# **PITT STREET NORTH SSD - 10375 MOD 2 – CHANGE TO BALUSTRADE AND CONDITION B11 WORDING**

Prepared for  
**PITT STREET DEVELOPER NORTH PTY LTD**

**PITT STREET INTEGRATED STATION DEVELOPMENT  
OVERSTATION DEVELOPMENT NORTH – SSD-10375 - Modification 02**

Figure 3 Proposed balustrade to be modified

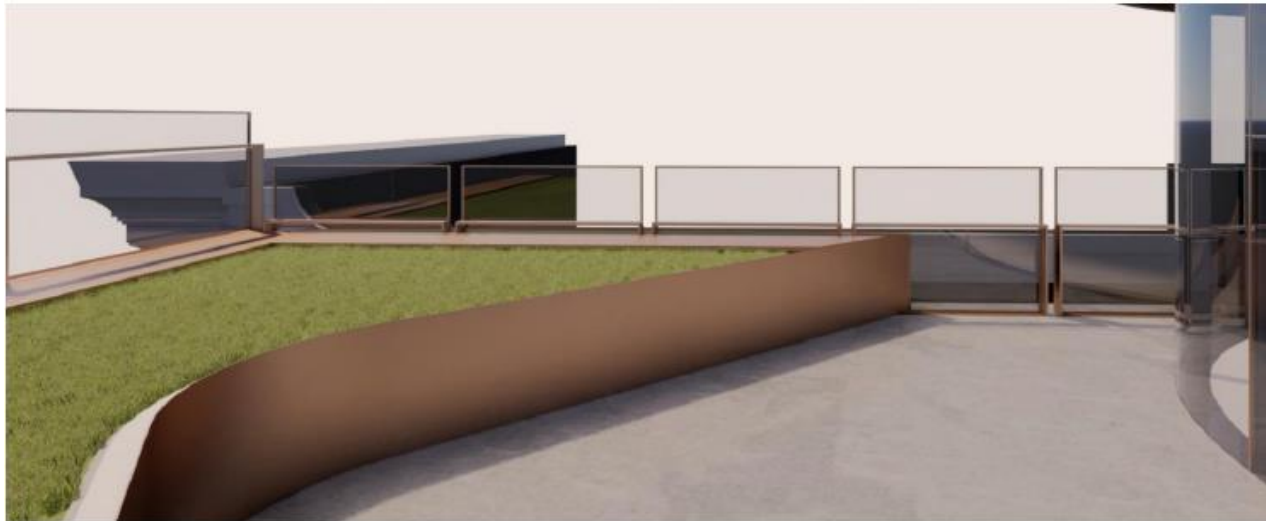
This modification also seeks to modify the height of the glazed balustrade between the L10 roof terraces and the National Building (Ashington Place) roof by 500mm from 1300mm to 1800mm above the finished floor level (FFL). This modification will ensure the balustrade aligns in terms of height with the adjacent balustrade and will remove the scalable element. The height of the horizontal handrail is also proposed to be increased to 1500 FFL. Refer to **Appendix A** for the Architectural Plans detailing the proposed modifications.

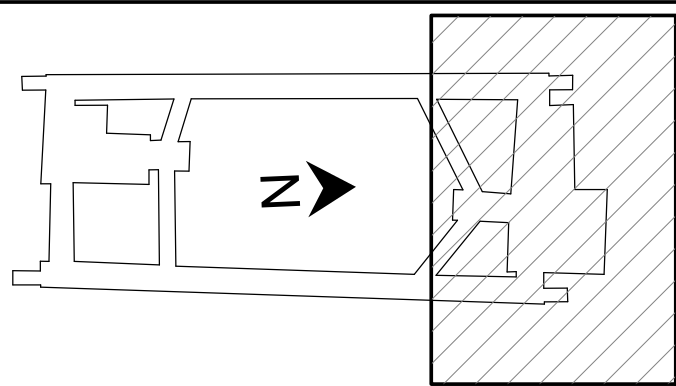
The attached drawing (SMCSWSPS-COX-OSN-AT-DWG-960004-G) and visual comparison identifies the balustrade between the L10 roof terraces and the National Building (Ashington Place) roof, which is proposed to be raised to 1,800mm above finished floor level (FFL) in order to align itself with the adjacent balustrade and to prevent climb-ability between the two sites.

Drawing Number	Rev	Name on Plan	Date	<del>SMCSWSPS-FOS-OSN-AT-DWG-960004</del>	<del>D</del>	<del>NORTH ELEVATION</del>	<del>29.10.20</del>	<del>SMCSWSPS-COX-OSN-AT-DWG-960004</del>	<del>F</del>	<del>NORTH ELEVATION</del>	<del>13.05.22</del>	SMCSWSPS-COX-OSN-AT-DWG-960004	G	NORTH ELEVATION	02/08/22
Drawing Number	Rev	Name on Plan	Date														
<del>SMCSWSPS-FOS-OSN-AT-DWG-960004</del>	<del>D</del>	<del>NORTH ELEVATION</del>	<del>29.10.20</del>														
<del>SMCSWSPS-COX-OSN-AT-DWG-960004</del>	<del>F</del>	<del>NORTH ELEVATION</del>	<del>13.05.22</del>														
SMCSWSPS-COX-OSN-AT-DWG-960004	G	NORTH ELEVATION	02/08/22
